Subject: MHI's Responses to US-APWR DCD RAI No.39

Responses to Request for Additional Information No.39 Revision 0

US-APWR Design Certification

RAI NO.: NO.39-548 REVISION 0
SRP SECTION: 19 – Probabilistic Risk Assessment and Severe Accident Evaluation
APPLICATION SECTION: 19.1
DATE OF RAI ISSUE: 7/29/2008

Figure 19-74.1 RCS water level transition

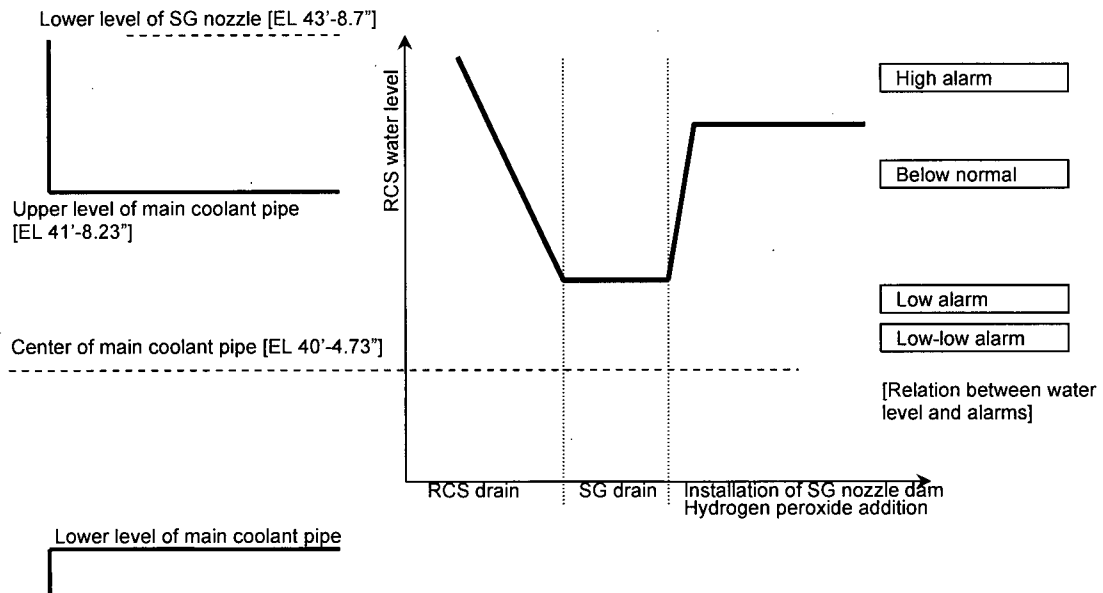
Define “mid-loop” for the US-APWR. To what elevation will the RCS be drained to allow steam generator maintenance and nozzle dam installation? Provide the location of the RHR hot leg suction nozzle.

Typical RCS water level transition during mid-loop operation is shown in Figure 19-74.1.

Mid-loop operation for the US-APWR is implemented for oxidation operation for purification of RCS water and SG drain for ECT operation. This operation involves RCS drain, SG drain, SG nozzle dam installation and hydrogen peroxide supplement. At first stage, during RCS drain operation, the RCS water level is decreased, but kept higher than the center of main coolant pipe. The second stage, the water level is kept below the upper level of main coolant pipe to communicate between air space and SG for SG drain. In this stage, if water level decreases lower than the certain threshold levels, low water level alarm or low-low water level alarm alerts the operators. Additionally, low pressure letdown line is automatically isolated by issuance of the low water level signal to prevent water level from decreasing. The third stage, after SG drain, the water level is increased and kept between upper level of main coolant pipe and lower level of SG nozzle. This water level allows installation of SG nozzle dam. In this stage, air/water interface is higher than the upper level of main coolant pipe and main coolant pipe is fully filled with water, so this operation reduces the possibility of air entrainment into the RHR pump suction. In this stage, high water level alarm or below normal water level alarm alerts the operators that water level is in abnormal condition.

The location of the RHR hot leg suction nozzle is located on the lower side of the main coolant pipe with the diagonal 45 degrees.
